SUTHERLAND SHIRE COUNCIL ASSESSMENT REPORT

Panel Reference	2016SYE051
DA Number	DA16/0388
LGA	Sutherland Shire
Proposed Development	Staged Concept Master Plan and a Stage 1 including construction of a residential flat building containing 124 dwellings, provision of infrastructure and services including access roads and public domain works, and site subdivision.
Street Address	Lot 1, Lot 3, Lot 4- 7 DP 31460, Lot P DP 413007, Lot 102 DP 868930 (Nos. 103-113) Willarong Road, Caringbah
Applicant	Tier Architects
Date of DA lodgement	4 April 2016
Number of Submissions:	Submissions received from 57 properties.
Recommendation:	Refusal
Regional Development Criteria (Schedule 7 of the SEPP (State and Regional Development) 2011	The development has a capital investment value of more than \$30 million and as such is nominated under part 2 of Schedule 7 of State Environmental Planning Policy (State and Regional Development) 2011.
List of all relevant 4.1591)(a) matters	<ul style="list-style-type: none"> • State Environmental Planning Policy(State and Regional Development) 2011 • State Environmental Planning Policy 65- Design Quality of Residential Flat Development (SEPP 65) and accompanying Ap

Figure 8: Building separation (Source: Applicants plans, red notation added by Council)

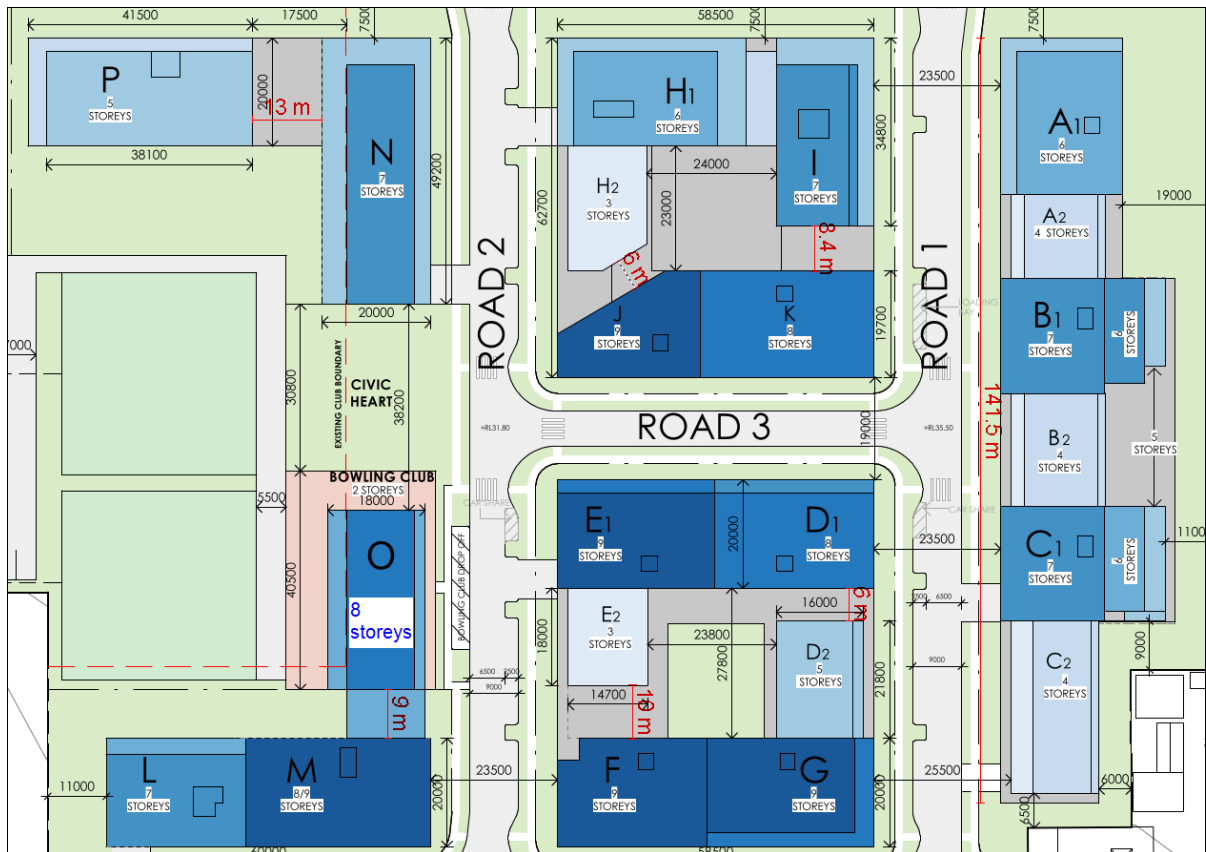
The building envelopes proposed under the Masterplan fail to reflect the ADG building separation and maximum building depth controls. Figure 8 below illustrates the proposed building separation distances; with the red annotations (by Council) representing areas which fail to comply with the ADG recommended distances.

There are multiple parts of the Masterplan which fail to provide the minimum separation distances recommended for different privacy interface conditions. Some envelopes fail to provide the minimum separation required between habitable rooms and balconies i.e. a 19m separation distance has been provided between building J (9 storeys) and E1 (9 storeys), where 24m is recommended.

Masterplan building envelopes set the block sizes for future development, and should facilitate buildings which are capable of complying with primary development controls such as the ADG to ensure high quality residential amenity. The proposed envelopes will constrain future development options, create difficulty in achieving the ADG design guidance and objectives, and will stifle future good design. The proposal therefore fails to satisfy clause 28(2) of SEPP 65, reproduced below:

The difficulty in achieving the minimum separation distances, is further evidence that the bulk and scale of the Masterplan (particularly on Lot 2) is not compatible with the characteristics of the site, and that the redistribution of GFA from the bowling club land does not result in a better planning outcome.

Figure 9: Architectural Plan Dwg. No. 117 Stage 2 Diagram (source: Applicant)

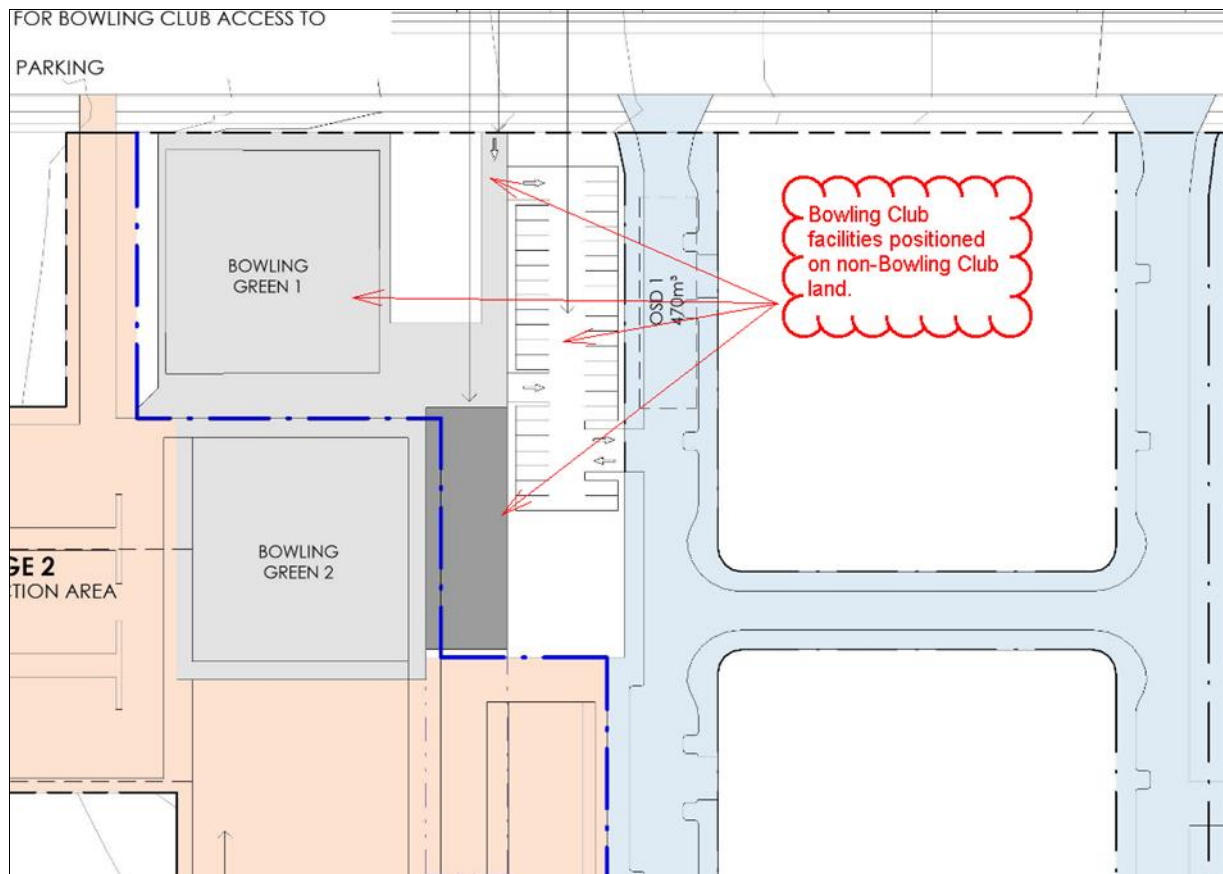
As a result of the subdivision/boundary adjustment required to facilitate stage 1, a number of facilities owned by the bowling club, including Bowling Green 1, a portion of the Clubhouse, the Maintenance Shed, the eastern parking area and the Bowling Club entry driveway will not be positioned on Bowling Club owned land, but rather the residential development site associated with the newly created Lot 2.

No detail has been provided to illustrate how the Bowling Club will remain operational throughout these processes. The Construction Management/Demolition Plan submitted by the applicant is lacking in detail and is outdated: relating to the demolition works already undertaken for the old High School Buildings (Drawing No 12700, GM Architects Sep 2013). Council has been provided with no detail regarding the relatively complex construction staging, such as a Staged Construction Plan, or an Operational Plan for the Bowling Club which details if/how the club will operate during and post demolition of half of the building, or the terms of the agreement is between the two landowners regarding land use access entitlements to Bowling Green 1, parking and access which are proposed to be located "offsite". Council therefore has inadequate information to determine the proposed Staged Masterplan and Torrens Title subdivision is acceptable.
